CITY OF ALBUQUERQUE

**RE: Wendy's Restaurant (Coors/Central Retail)
Coors & Central
Grading and Drainage Plan
Engineers Stamp Date 2/16/15 (K10D025C)**

Grading Plan

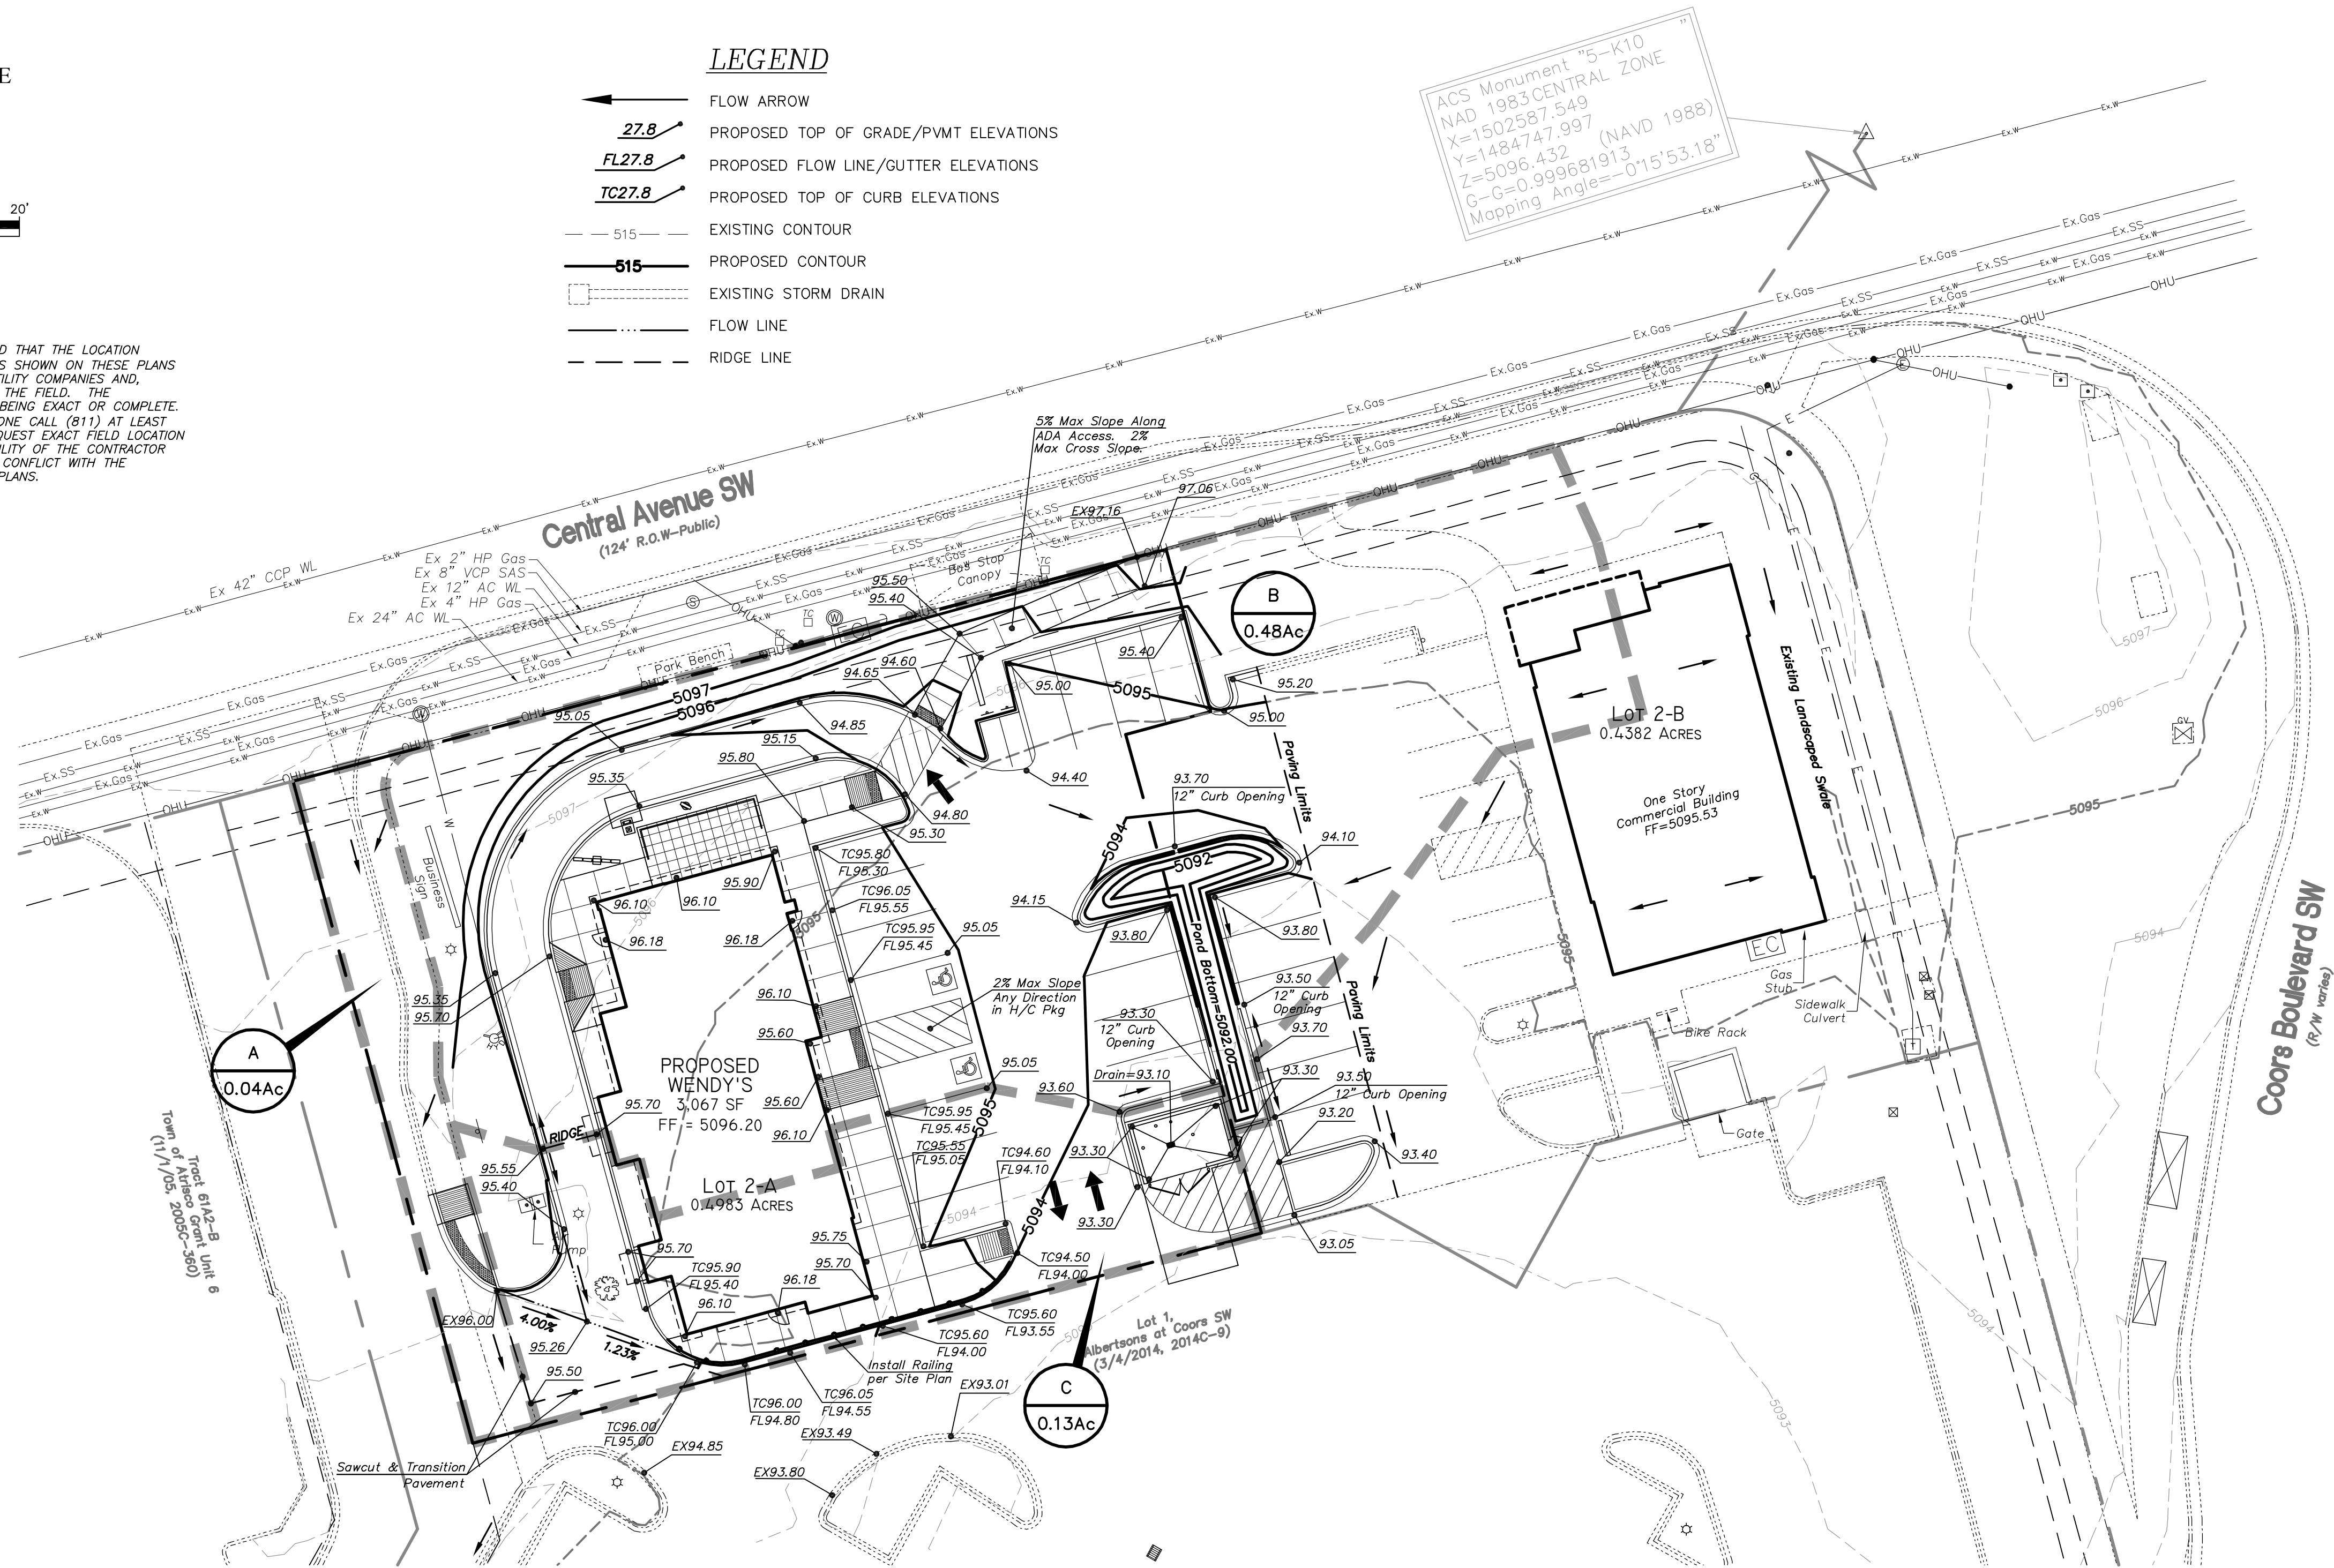
Based upon the information provided in your submittal received 3/25/15, this plan is approved for Grading Permit and Building Permit.

Please attach a copy of this approved plan to the construction sets in the permitting process prior to sign-off by Hydrology.

Prior to Certificate of Occupancy release, Engineer Certification per the DPM checklist will be required.
